# UNITED STATES PATENT AND TRADEMARK OFFICE

APPLICATION NO.	FILING DATE	FIRST NAMED INVENTOR	ATTORNEY DOCKET NO.	CONFIRMATION NO.
10/740,017	12/18/2003	Michael Jackson II	706804US1	1703
24938	7590	12/12/2006	EXAMINER	
DAIMLERCHRYSLER INTELLECTUAL CAPITAL CORPORATION			FIGUEROA, ADRIANA	
CIMS 483-02-19			ART UNIT	
800 CHRYSLER DR EAST			PAPER NUMBER	
AUBURN HILLS, MI 48326-2757			3637

**Office Action Summary**

## **DETAILED ACTION**

**Roberts (U.S. 3,953,630)**

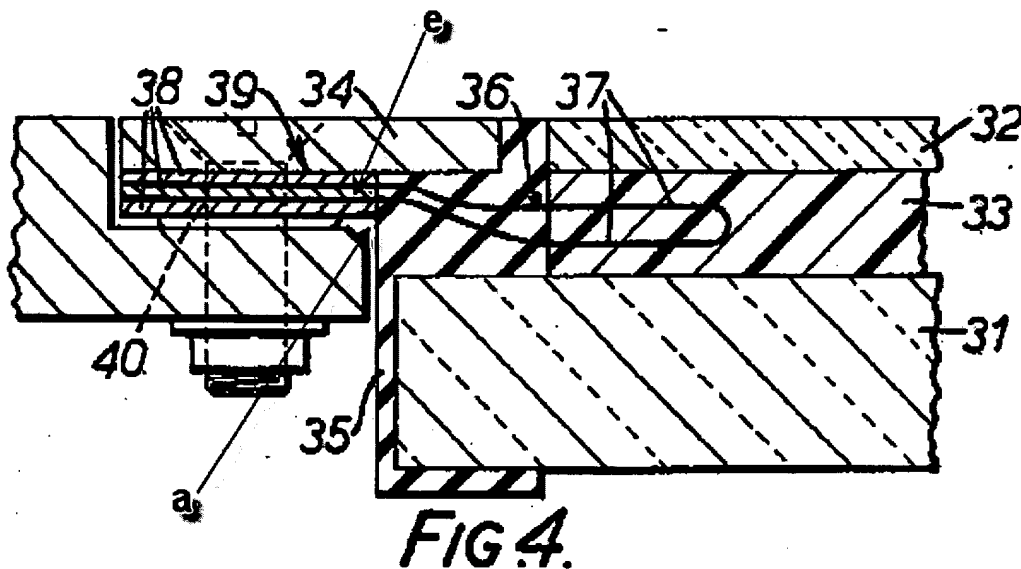
Regarding claim 1, Robert discloses a window assembly comprising: a first glass layer (10); a second glass layer (11) bonded to the first glass layer by an adhesive (12), the adhesive defining a spacing between the first and second glass layers; and an engagement module (e) having a portion adapted for bonding in the spacing between the first and second glass layers, (annotated Figure 1). The phrase "the engagement module adapted to connect the window to the window opening mechanism" is considered intended use and is given no patentable weight.

Regarding claim 3, Roberts discloses a window wherein the engagement module (e)

comprises a border (b) for bonding between the first (10) and second (11) glass layers and a central hub (16), (annotated Figure 1). The phrase "adapted to engage the window opening mechanism" is considered intended use and is given no patentable weight.

Regarding claim 7, Roberts discloses a window wherein the central hub (16) comprises an aperture (28), (annotated Figure 1). The phrase "for lockingly engaging the window opening mechanism" is considered intended use and is given no patentable weight.

Regarding claim 8, Roberts discloses a window wherein the engagement module (e) is bonded to a lower edge (l) of the window, (annotated Figure 1). The phrase "for vertical movement of the window by the window opening mechanism" is considered intended use and is given no patentable weight.

5. Claim 4 is rejected under 35 U.S.C. 103(a) as being unpatentable over Roberts (U.S. 3,953,630), Figure 1 in view of Roberts (U.S. 3,953,630), Figure 4. Roberts in Figure 1 discloses as discussed above but does not disclose an air gap between the

engagement module and the adhesive. However, Roberts in Figure 4 teaches an air gap between the engagement module and the adhesive (annotated Figure 4).

Klosterman (U.S. 6,330,764)

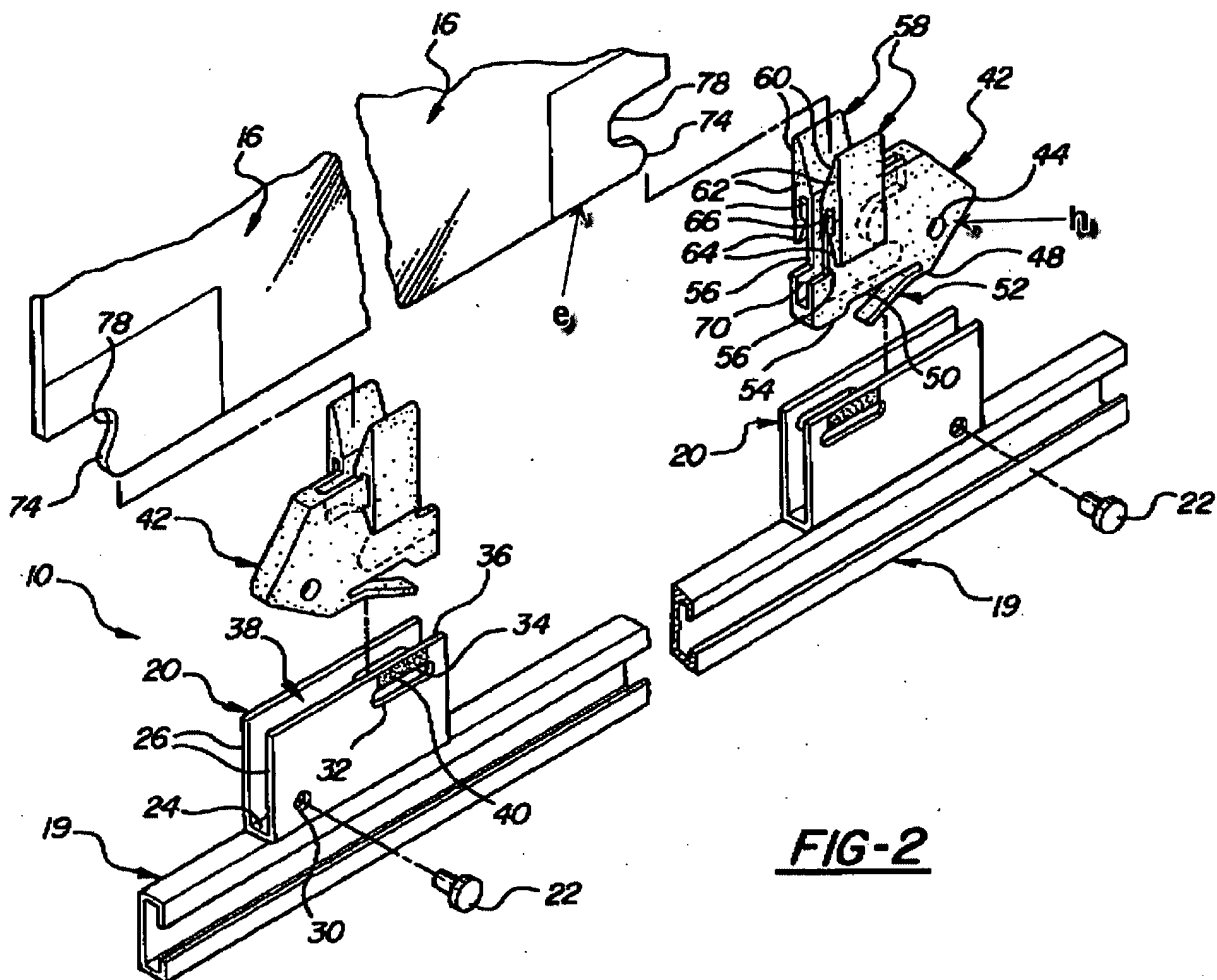
Regarding claim 5, Roberts discloses a window having a central hub (16), but does not disclose the central hub having a wedge-shaped portion. However, Klosterman teaches a window wherein the central hub (h) has a wedge-shaped portion, (annotated Figure 2). Therefore, it would have been obvious to a person having ordinary skill in the

Regarding claims 9 and 11, Roberts discloses a window assembly having a lower edge (l), but does not disclose the lower edge defining a semi circular indentation for receiving the engagement module, the engagement module forming a continuation of the lower edge. However, Klosterman teaches a window assembly having a lower edge (e) defining a semi circular indentation (78) for receiving the engagement module (42), the engagement module forming a continuation of the lower edge, (annotated Figure 2). Therefore, it would have been obvious to a person having ordinary skill in the arts at the time of the applicant's invention to modify the lower edge of Roberts to have a semi circular indentation as taught by Klosterman in order to position and retain the window glass.

Regarding claims 12 and 13, Roberts discloses a window assembly having an edge (I), and a first (10) and second (11) glass layers, but does not disclose the first and second glass layers defining a semi circular indentation in the edge, the engagement module being received in the indentation. However, Klosterman teaches a window assembly wherein the glass layer (16) has a semi circular indentation (78) in the edge (e), the engagement module being received in the indentation, (annotated Figure 2).
